UNITED STATES PATENT AND TRADEMARK OFFICE

APPLICATION NO.	FILING DATE	FIRST NAMED INVENTOR	ATTORNEY DOCKET NO.	CONFIRMATION NO.
10/695,235	10/28/2003	Christopher Alan Adkins	2003-0258.01	4961

Office Action Summary	Application No. 10/695,235	Applicant(s) ADKINS ET AL.	
	Examiner Anthony T. Dougherty	Art Unit 2863

Fig. 6

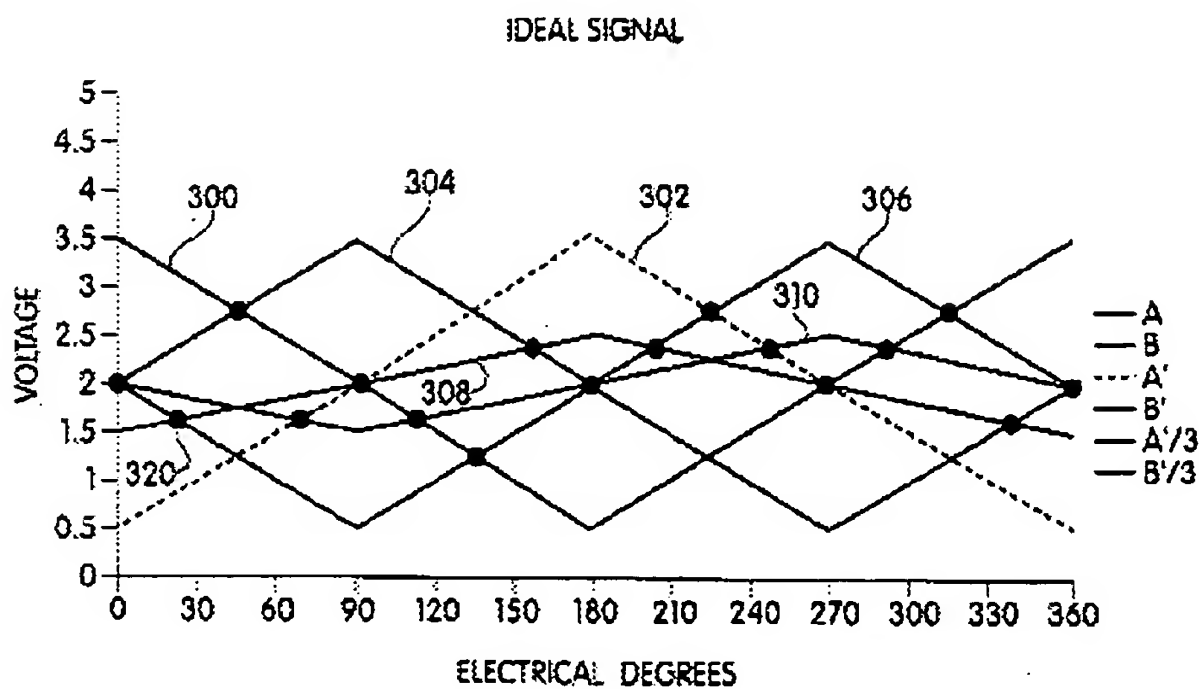
This 102 rejection relies heavily on Figure 6 of the prior art so it is included here with an explanation as to corresponding attributes with the instant application.

As can be seen in Figure 6 the signal indicated as A begins at a voltage of 3.5 at 0 degrees and corresponds to the first output signal of the instant application, the signal indicated as B begins at 2 volts at 0 degrees and 3.5 volts at 90 degrees and corresponds to the second output signal of the instant application, and the signal B' represents the inverse of the second output signal and is at 2 volts at 0 degrees and at 0.5 volts at 90 degrees.

With regard to claim 10 Snyder discloses a method for determining the distance moved by a component operatively coupled to an analog encoder having analog first and second output signals (see abstract) by calculating at least one of a first inverse signal which is the inverse of the first output signal and a second inverse signal which is the inverse of the second output signal (see column 3 line 36-38 & Figure 6), calculating the distance moved by the component from a previous position using one of an ascending or descending region of the first or second output signal wherein the previous position is the position of the component corresponding to a crossover level of two signals chosen from the group consisting of the first output signal the second output signal and the at least one inverse signal (see Figure 6).

With regard to claim 11, and applying the rejection of claim 10 above, Snyder discloses the crossover level corresponding to the first high level is determined from at least one of the current value and the most recent previous value of the first output signal and the inverse signal when it has been determined that the ascending first output signal crossed the inverse signal (see

Figure 6 the intersection indicated by a dot between 300 and 330 degrees [approx. 315°] which is the intersection of A and B').

With regard to claim 19, and applying the rejection of claim 10 above, Snyder discloses the step of calculating the distance moved by the component using a different one of the ascending or descending region of the first or second output signal upon a crossover of two signals chosen from the group of the first output signal, the second output signal, and at least one inverse signal (see Figure 6 & column 5 line 47-57).
